ADDENDUM No. THREE

Project Name:	Campground Improvements Cape Henlopen State Park
Project No.:	CH-44
Contract No.:	2015-CH-300
Date of Issue:	July 20, 2015
Notice No. 1:	Attach this addendum to the Project Manual for this project. It modifies and becomes part of the Bidding Documents. Work or material not specifically mentioned herein is to be as described in the main body of the specification and as shown on the drawings.
Bids Due:	Tuesday, August 2, 2016 at 2:00 PM Auditorium DNREC, Division of Parks and Recreation 89 Kings Highway, Dover DE 19901

SITE DEMOLITION PLAN

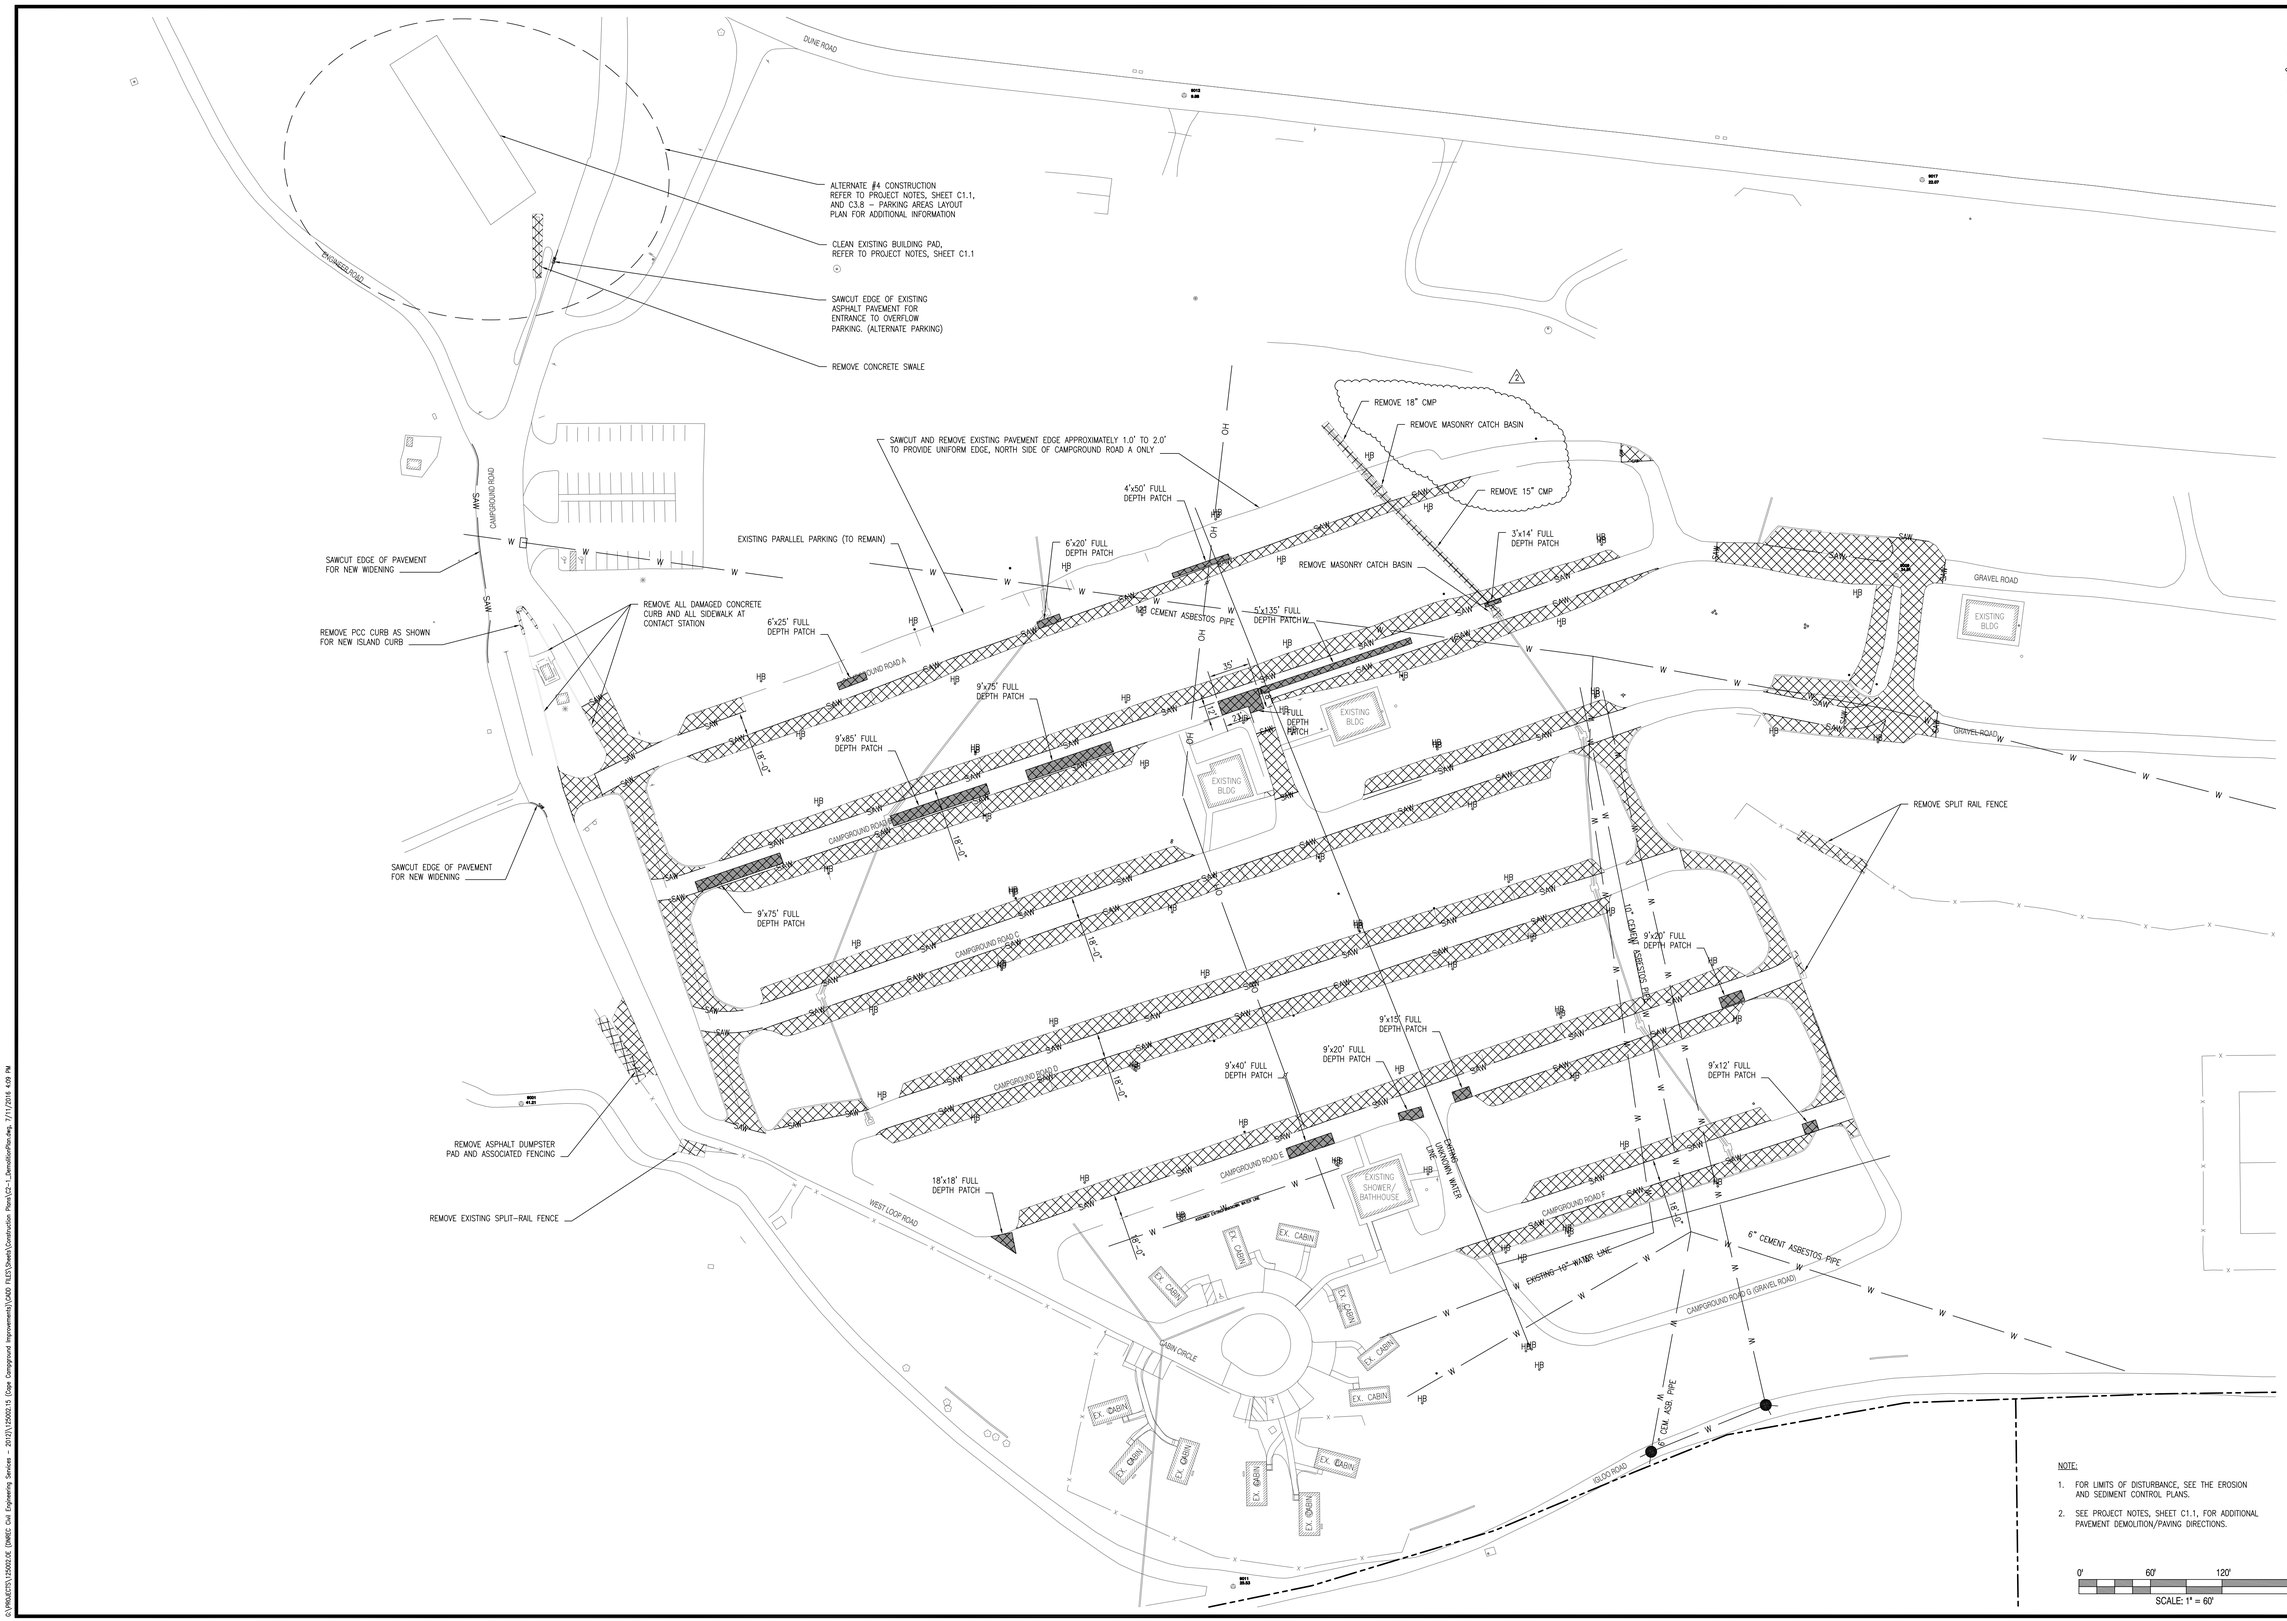
1 Sheet C2.1 Site Demolition Plan: The 18” CMP, 15” CMP and masonry catch basin are to be removed at the northeast area of the Campground. This sheet has been revised and is included with this Addendum.

RV PARKING PLAN

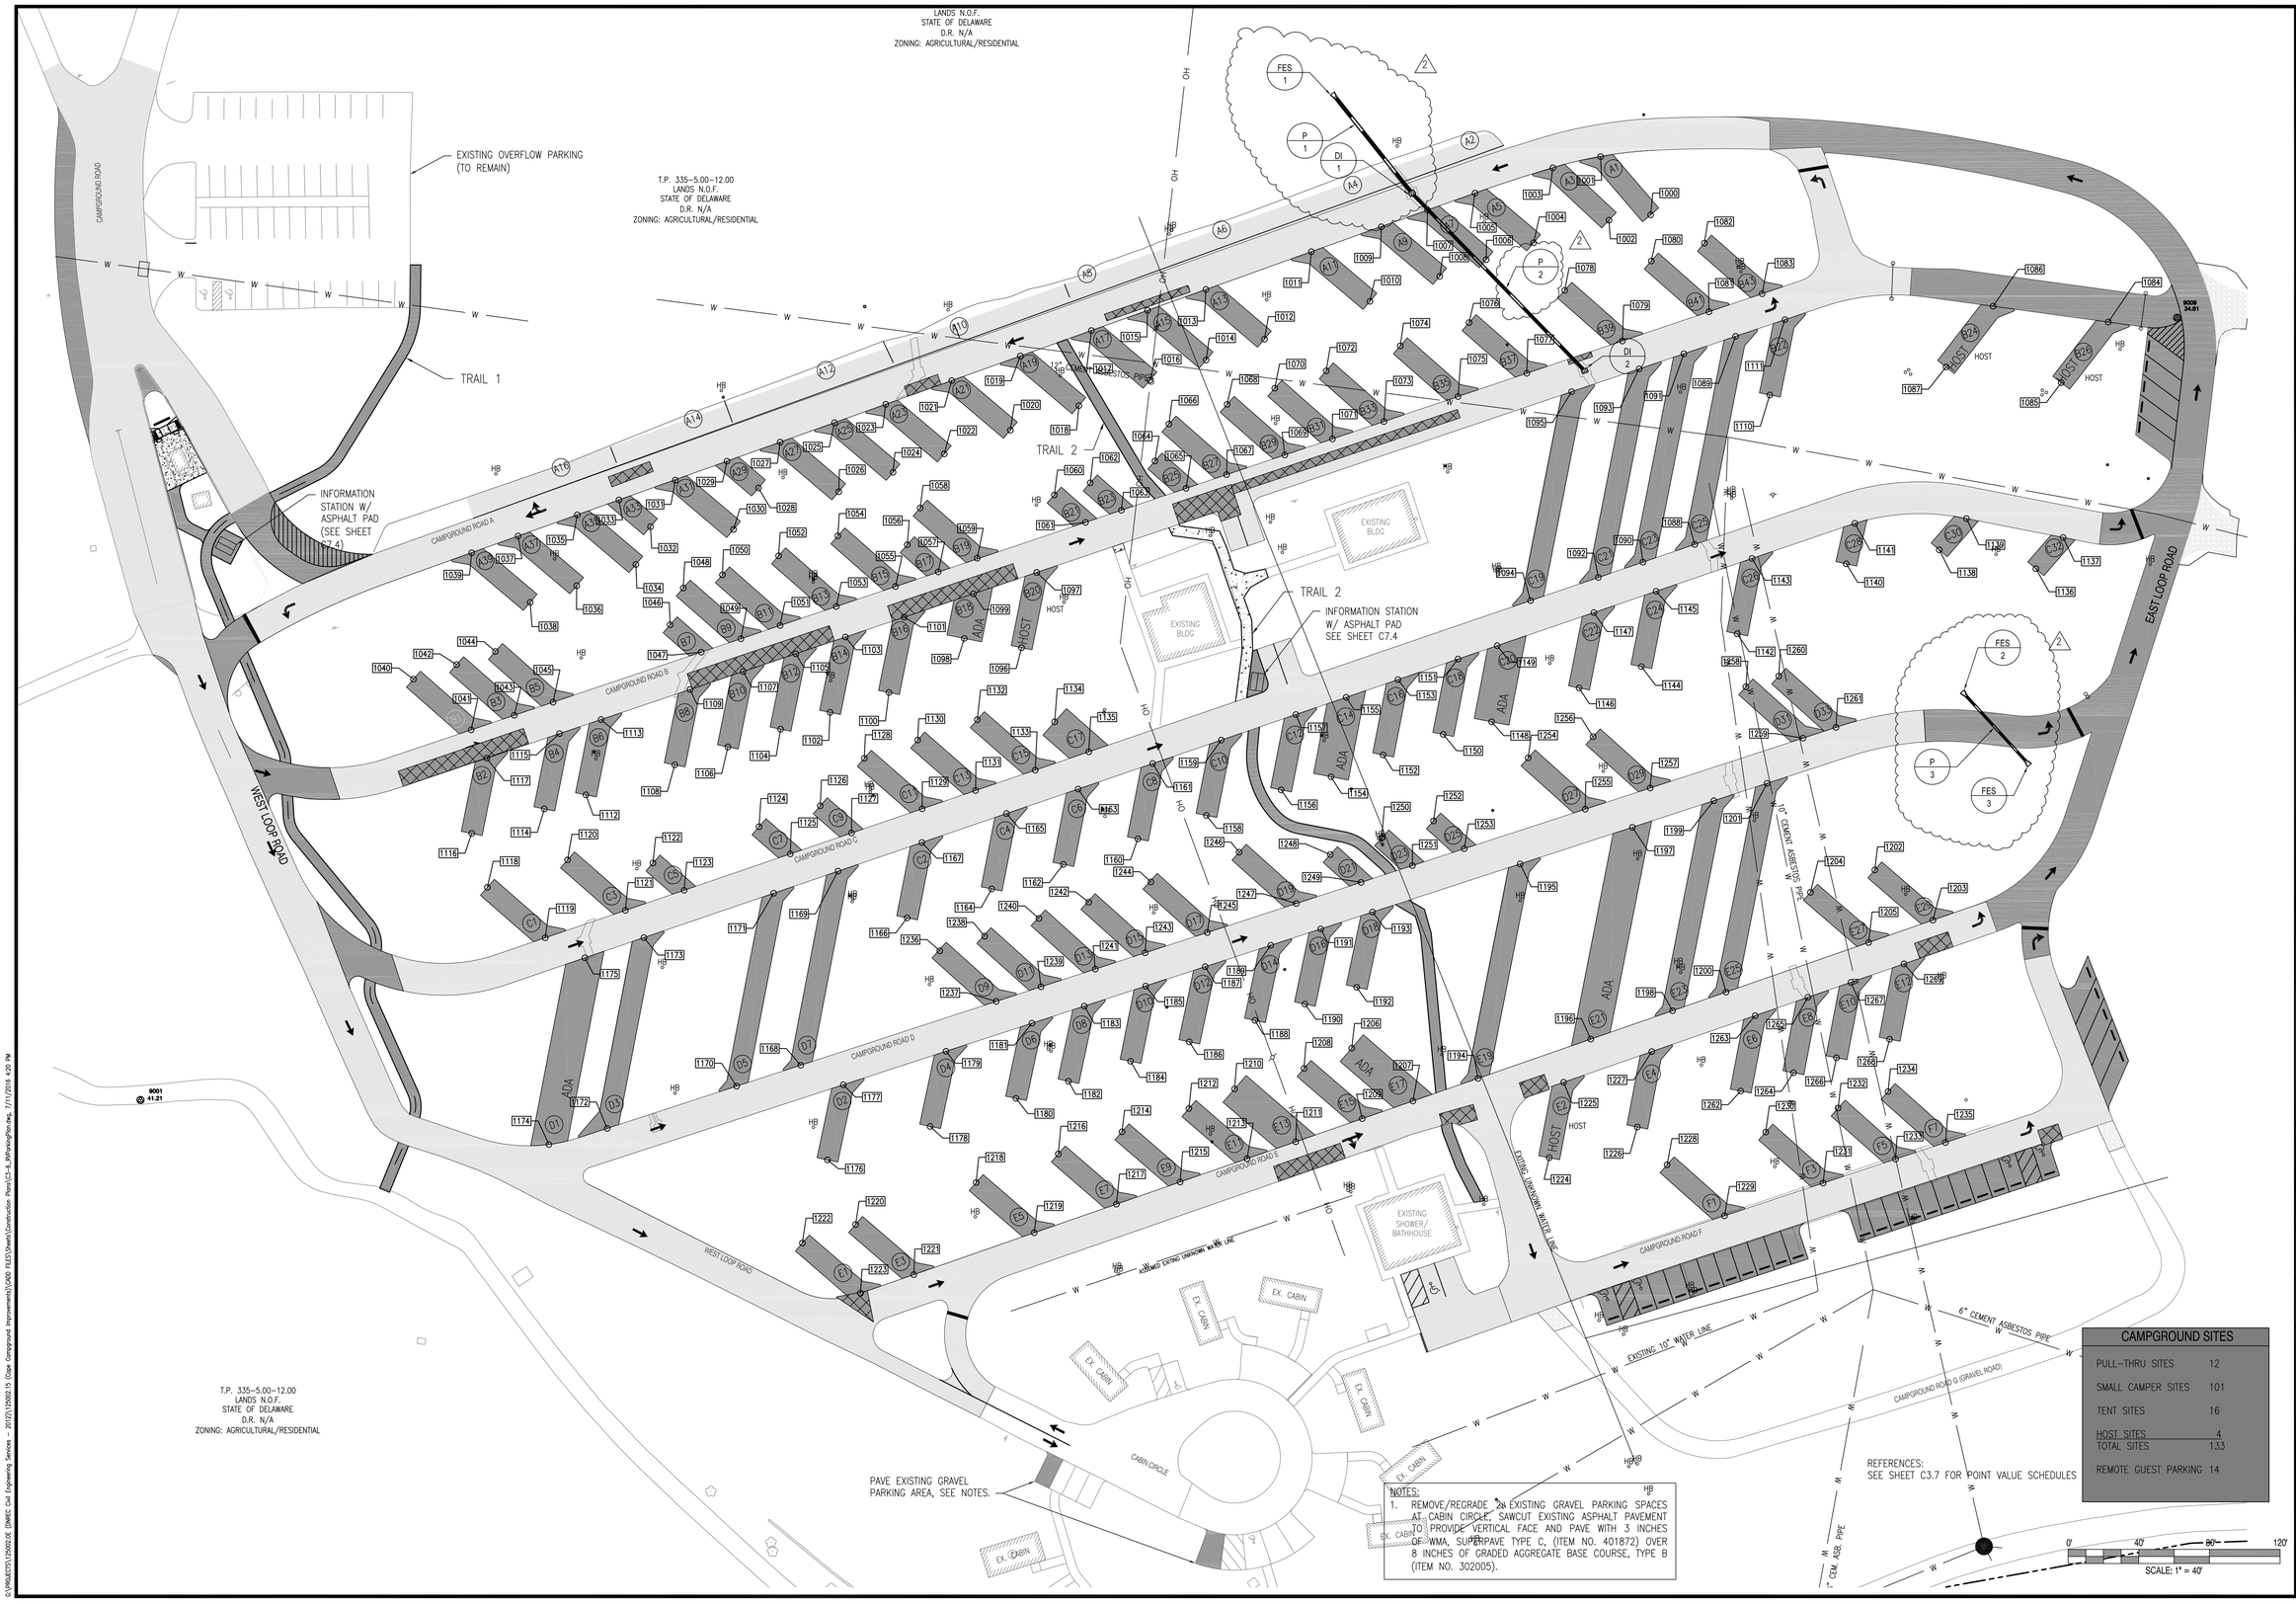
A. Install new 15” RCP, 18” RCP and drainage inlet as shown in the northeast area of the Campground.
B. Install new 15” RCP and 12” RCP with flared ends as shown crossing Road C at the east end.
C. This sheet has been revised and is included with this Addendum.

UTILITIES DETAILS

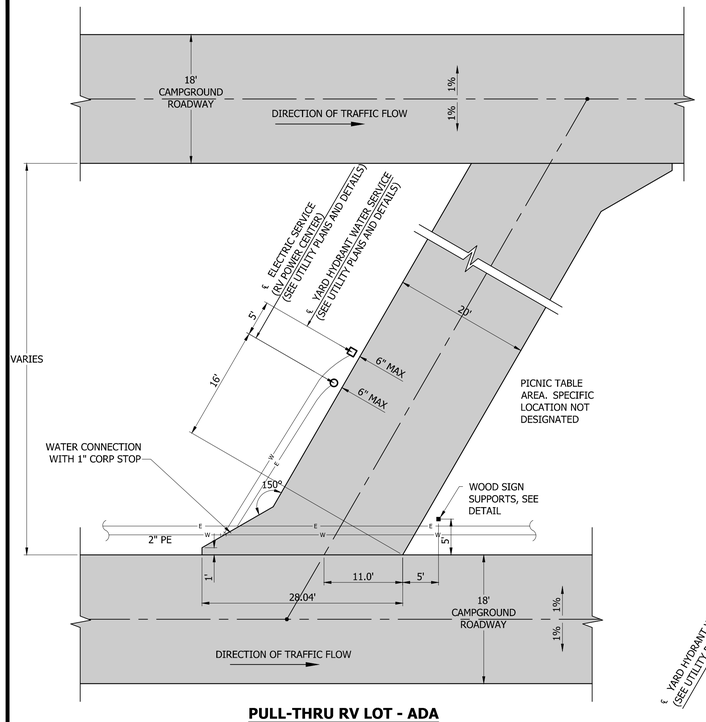
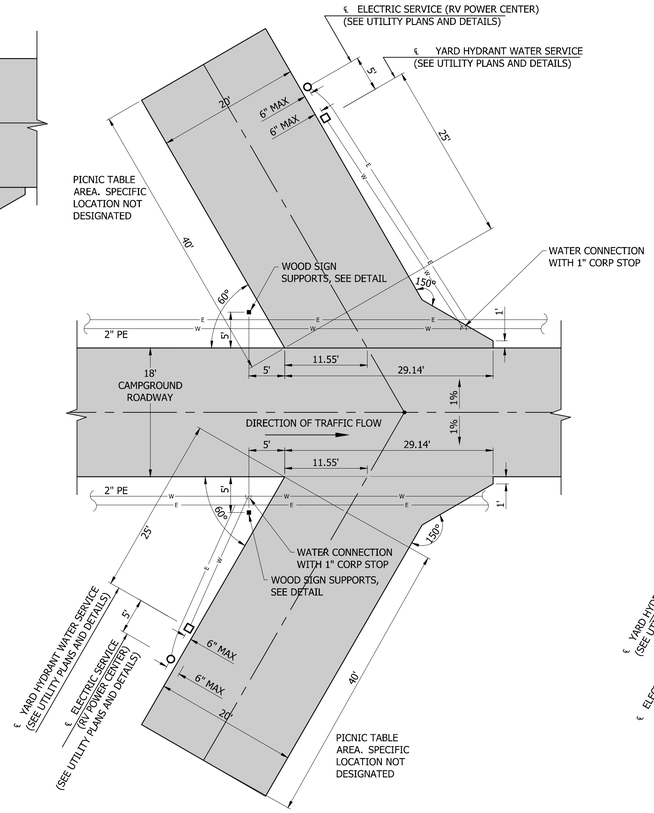
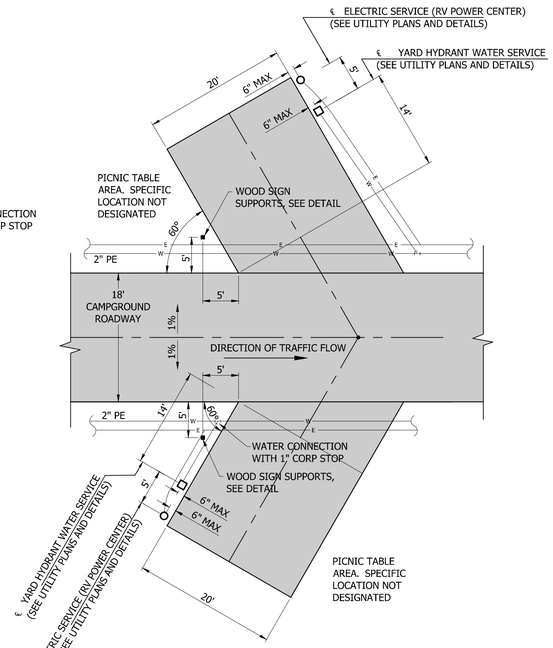
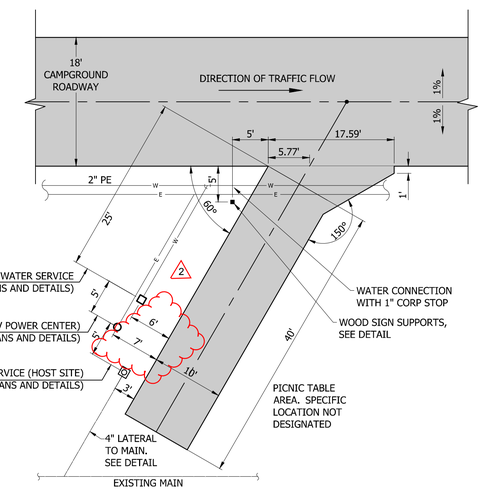
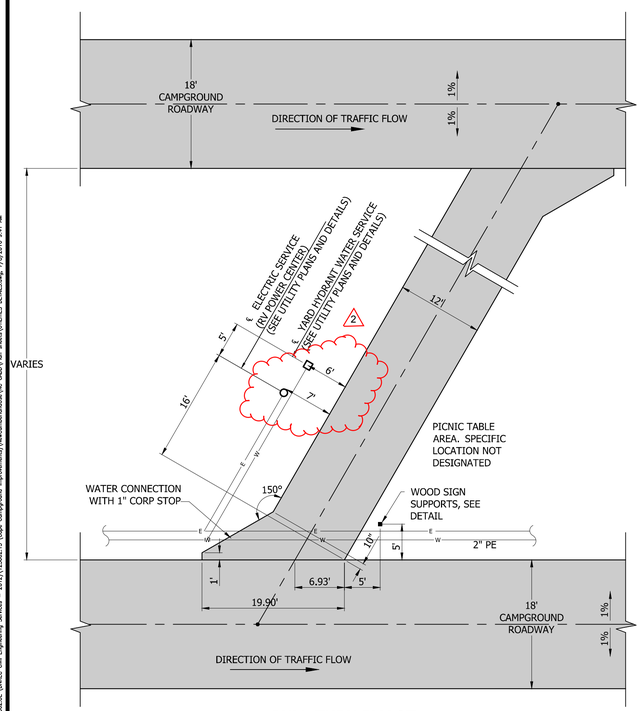
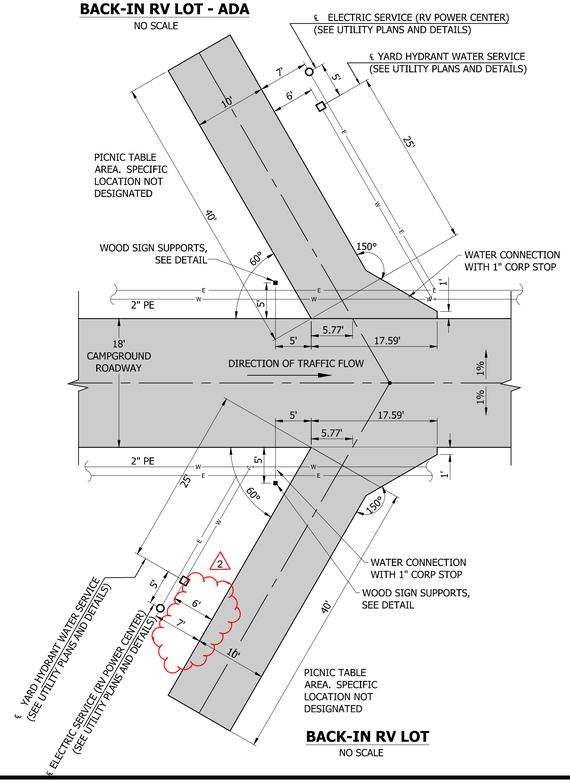
4 Sheet C8.6 Utilities Details: The locations of the yard hydrant and power center have been revised. This sheet has been revised and is included with this Addendum.

ELECTRICAL DETAILS

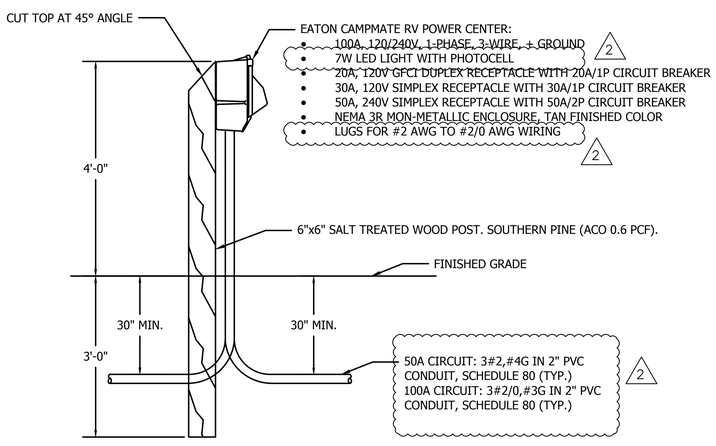
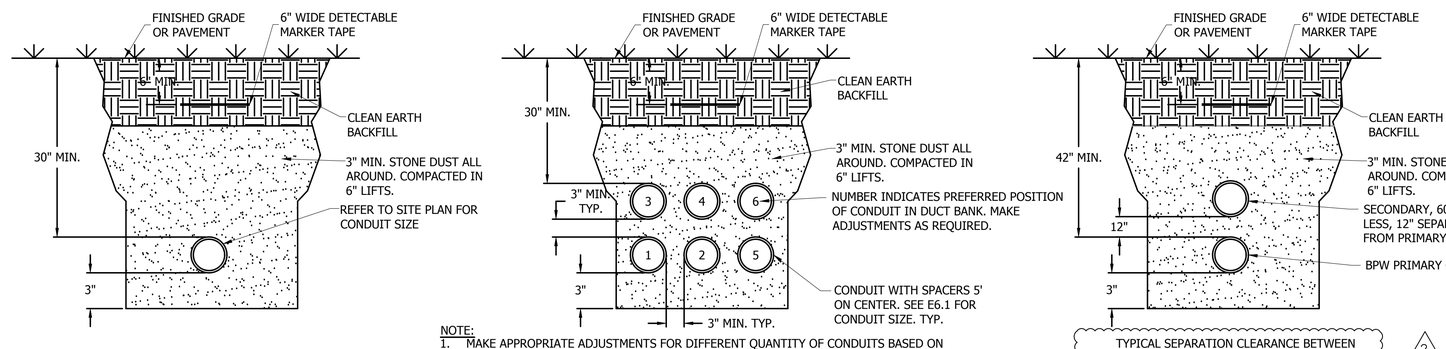
A. Detail for separation distance between medium-voltage run and 600V or less run has been revised.
B. The Electrical Legend has been revised.
C. Electrical Abbreviations has been revised.
D. The Typical Power Post Detail has been revised.
E. This sheet has been revised and is included with this Addendum.
